**RE: Alaska Gold Company (AGC), Nome Rock Creek Mine Project, Permit Decision Appeal**

I have reviewed the DNR's Reclamation Plan Approval F20069578. I am appealing the decision according to 11 AAC 02 per the appeal procedures indicated in the reclamation plan approval dated August 9, 2006. I believe I have standing to appeal the decision as I have commented at every opportunity and wish to indicate my dissatisfaction with DNR's decision. Only now have I had adequate time since the June 1, 2006 public notice to analyze the **ROCK CREEK MINE, PLAN OF OPERATIONS, VOLUMES 4 through 8, Reclamation Plan, Water Management Reports, Thermal and Seepage Evaluation, Monitoring Plan, & Geochemistry & Groundwater Reports for Rock Creek & Big Hurrah, May, 2006**. I feel those volumes are crucial to fully understanding the environmental and human impacts from this project and are the most relevant pieces of information to my appeal and DNR's decision. Because of the additional time allowed under this appeal comment period I was able to enter Big Hurrah and Rock Creek water & geochemistry data into Microsoft® Excel© that I was **NOT** able to do during the Alaska Coastal Management Program's co

Figure 1

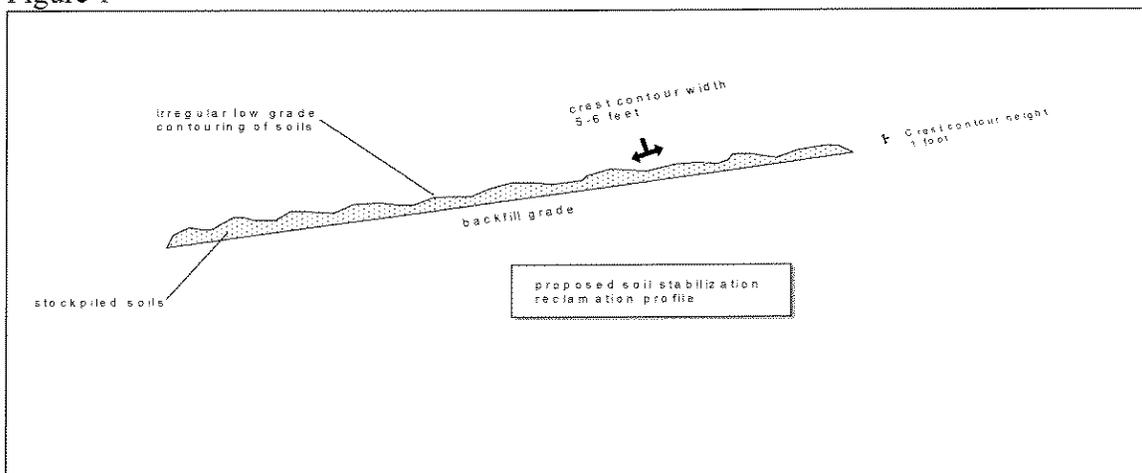
Solifluction lobes are common land forms in this arctic environment likely due to the impermeability of permafrost zones or shallow bedrock. It is likely that AGC's proposed backfill grades will become frozen and lend themselves to soil movement or slumping down gradient when soils become water saturated; DNR should require low grade contouring with engineered placement of soils to resist slumping. Without engineered placement of soils re-vegetation may become slowed. AGC is proposing grading of top soil cover or backfill on 25 meter benches, DNR should review some other method of protective capping of backfilled waste rock or development rock. Figure 1 is my proposed reclamation profile for reclaimed vegetative foundations. Low grade contouring may result in stronger plant communities and may also prevent runoff perpendicular to contour lines or crests and may prevent slumping.

Figure 2

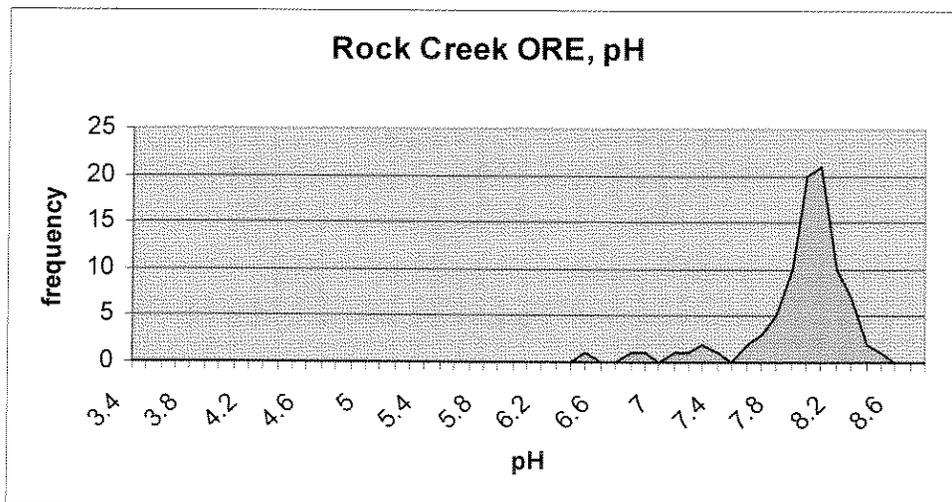
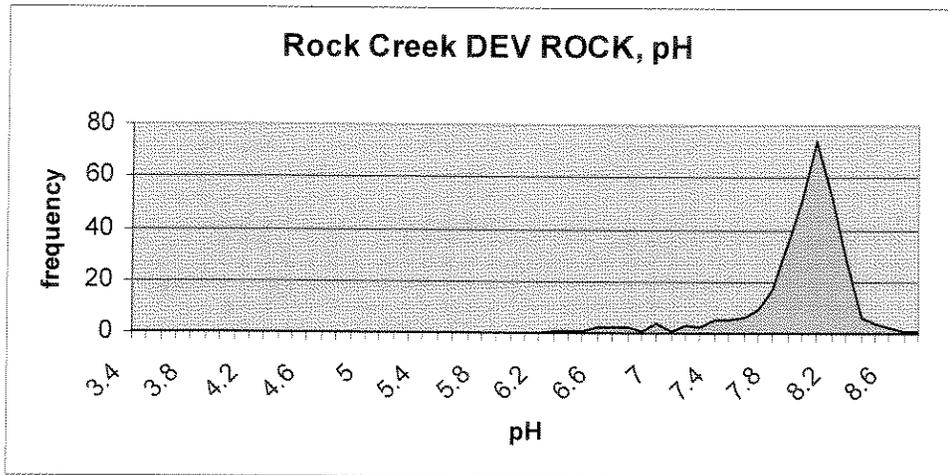
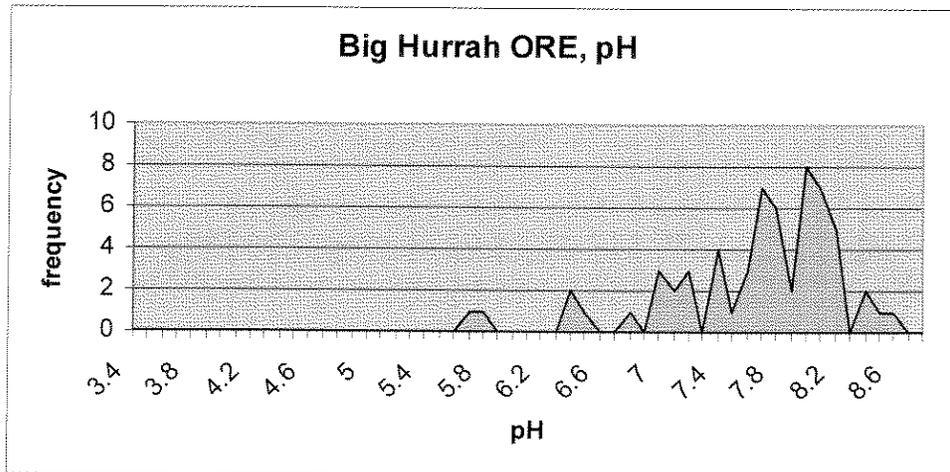
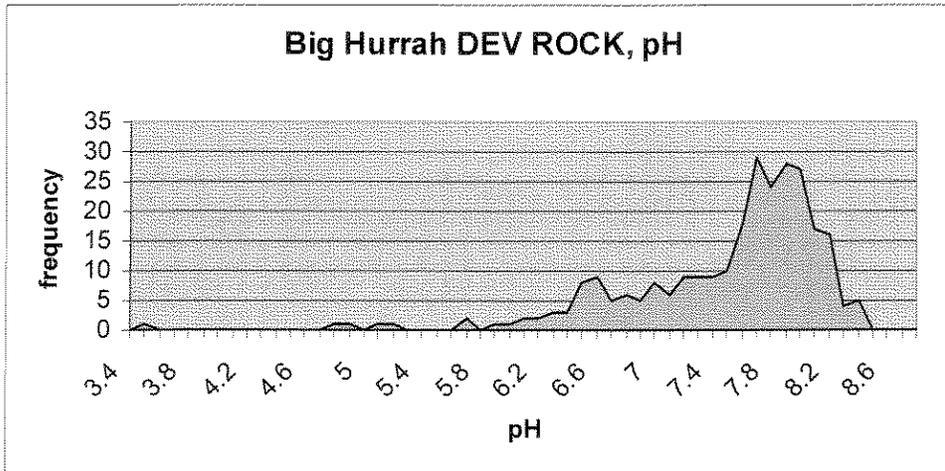
Figures 2 through 5 are frequency diagrams of saturated paste pH of Big Hurrah and Rock Creek ore and development rock. They show a skewed distribution with a majority of measurement between pH 7.8 to pH 8. The presence of acidic material in all rock samples is of concern and may mobilize elemental components in addition to elements that were shown to release immediately such as As, Sb, & Mo.

Figure 6

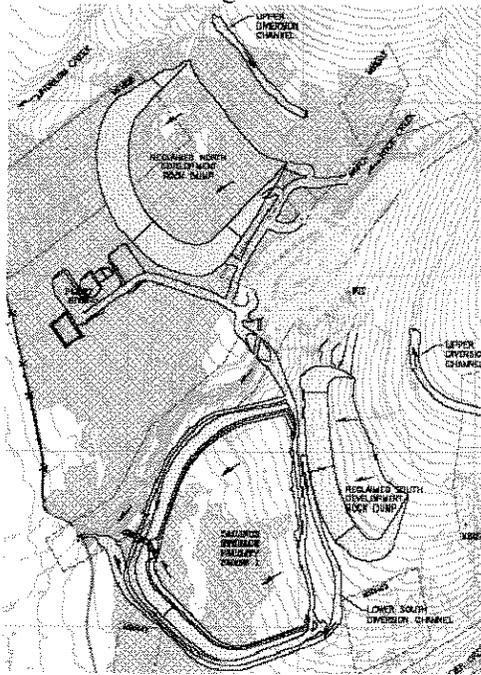
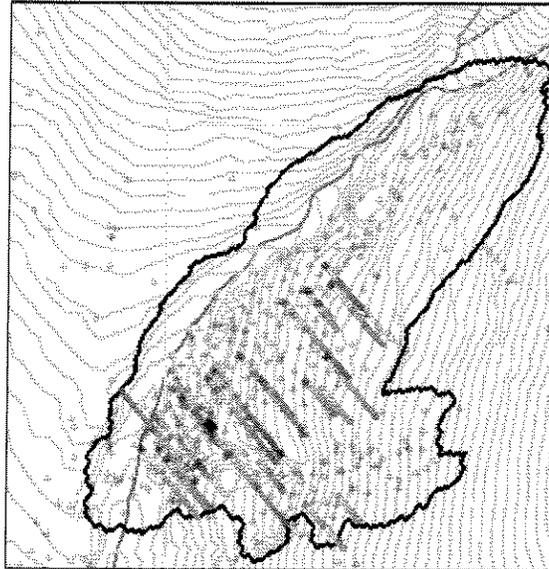
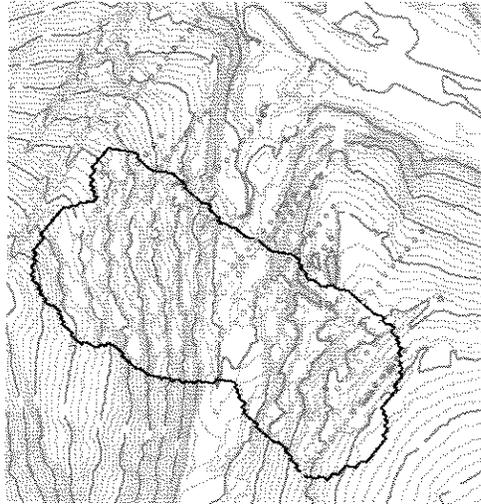
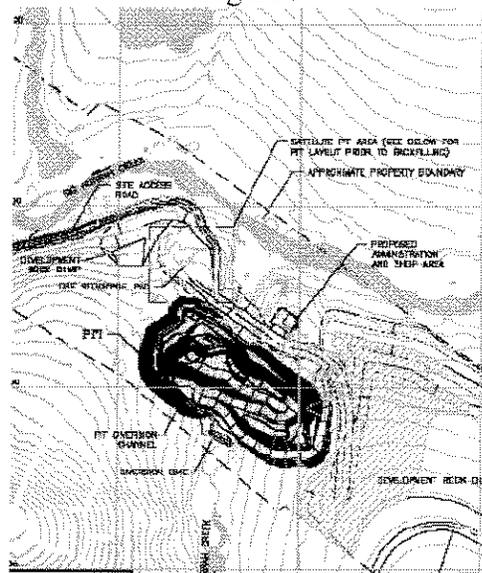
Figures 6 through 9 come from Volume 4 & 8 and show the spatial orientation of drill samples and pit locations. The drill sample locations do not cover the entire area of the pit locations at Big Hurrah or Rock Creek. **DNR should address how the drill locations were placed in relation to the pits and adjust the permit or reverse it decision.** Like the sample depths a power analysis should be done to address the relationship of drill locations and pit locations. Pit locations are approximate and AGC may change or move the pit locations. **Without sufficient statistical analysis of the drill locations the public will not know if DNR is proceeding with caution or appropriately.**
